YUCCA MOUNTAIN – SUPPLEMENTAL RESPONSE – REQUEST FOR ADDITIONAL INFORMATION (RAI) –VOLUME 2, CHAPTER 2.1.1.4, SET 3 (DEPARTMENT OF ENERGY’S SAFETY ANALYSIS REPORT SECTION 1.7) – Identification of Event Sequences

RAI Volume 2, Chapter 2.1.1.4, Third Set, Number 1, Supplemental Question 6:

Response Tracking Number: 00409-04-00

RAI: 2.2.1.1.4-3-001

Figure 1. Slice View of Rock Mass Temperature (K) Distribution for Selected Time Intervals with Instantaneous Emplacement of Waste

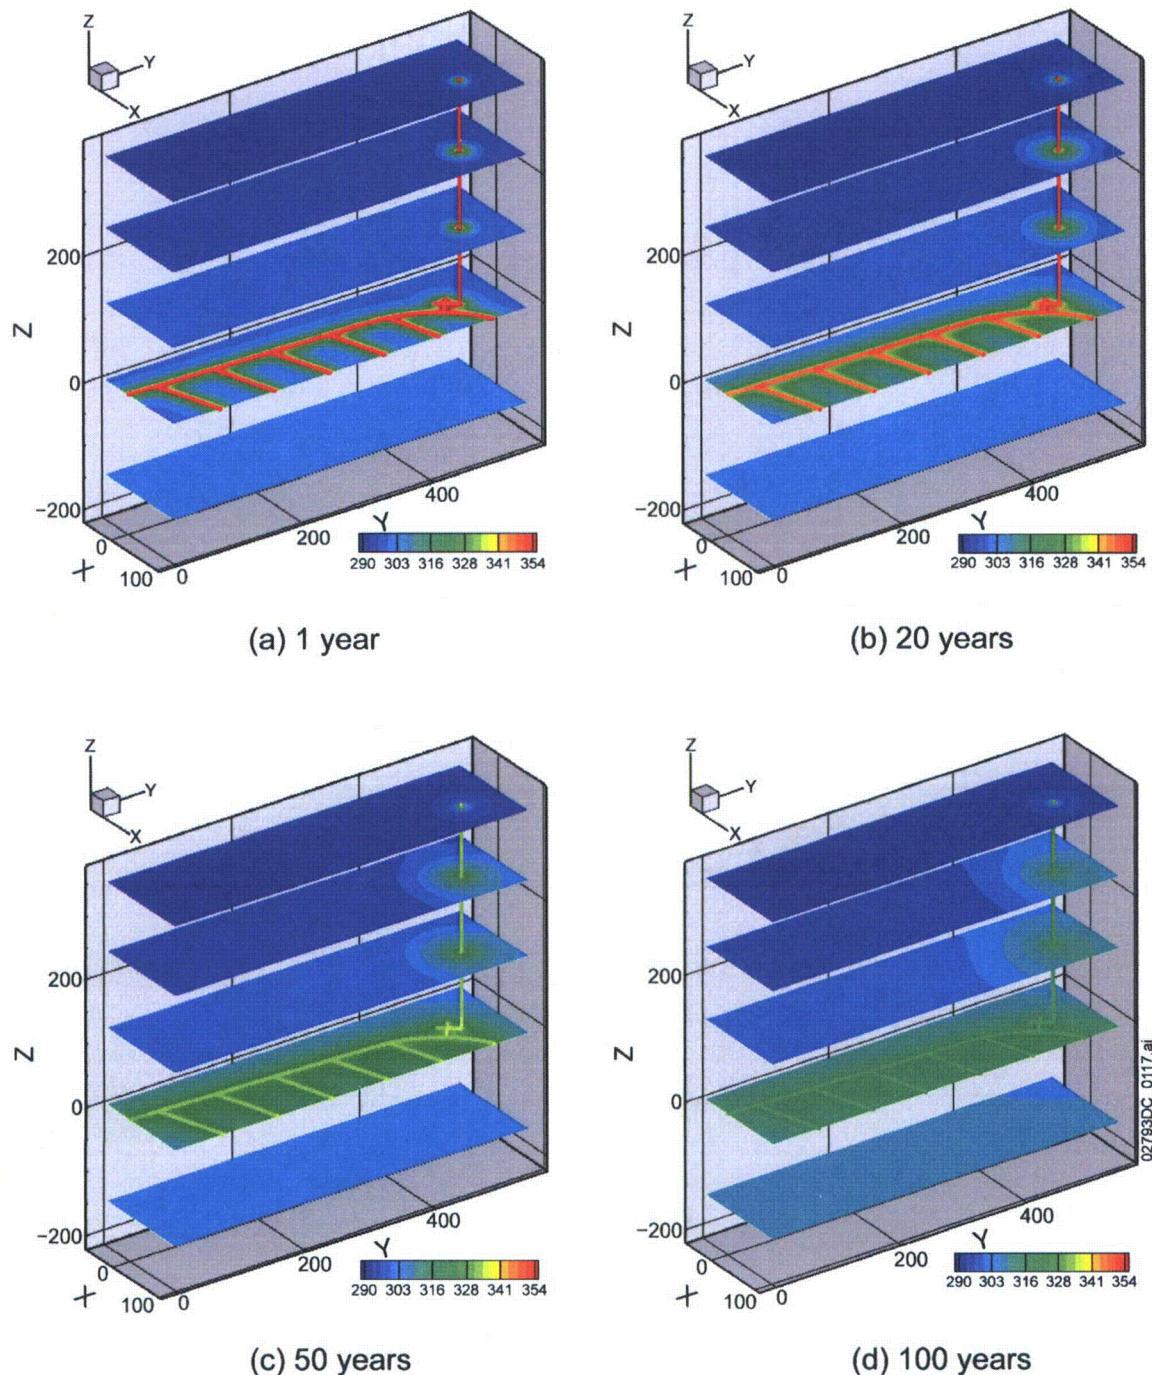
Clarify the basis for using plain concrete as ground support for ventilation exhaust shafts that could be subject to thermal stresses due to heating from exhaust air (SAR 1.3.3.3.1).

As illustrated in SAR Figure 1.3.4-16, the emplacement drift exhaust air temperature peaks shortly after emplacement of the waste packages and decreases steadily thereafter. Outlet air temperatures for typical 600 m and 800 m long emplacement drifts peak at approximately 83°C and 100°C, respectively (BSC 2008b¹, Tables 7 and 9). Throughout the preclosure period, the shafts will experience lower air temperatures than the calculated maximum exhaust air temperatures reported in Figure 1.3.4-16 because of the phased emplacement of the waste over time, such that the heated air stream exhausting out of multiple emplacement drifts toward a single shaft will be a mix of different air temperatures, and the exhaust shaft concrete would not experience the maximum possible air temperatures from each drift. Also, as documented in the *Temperature Change in Exhaust Airflow* calculation (BSC 2008c), a computational fluid dynamics-based simulation of the airflow heat transfer process (using the computational code FLUENT), the heated air from the emplacement drift cools as the air moves through the exhaust main (by heat convection to the ambient rock) and up the exhaust shaft (by adiabatic cooling) to the surface. Figure 1 illustrates time history results from the FLUENT evaluations of the shaft airflow temperatures.
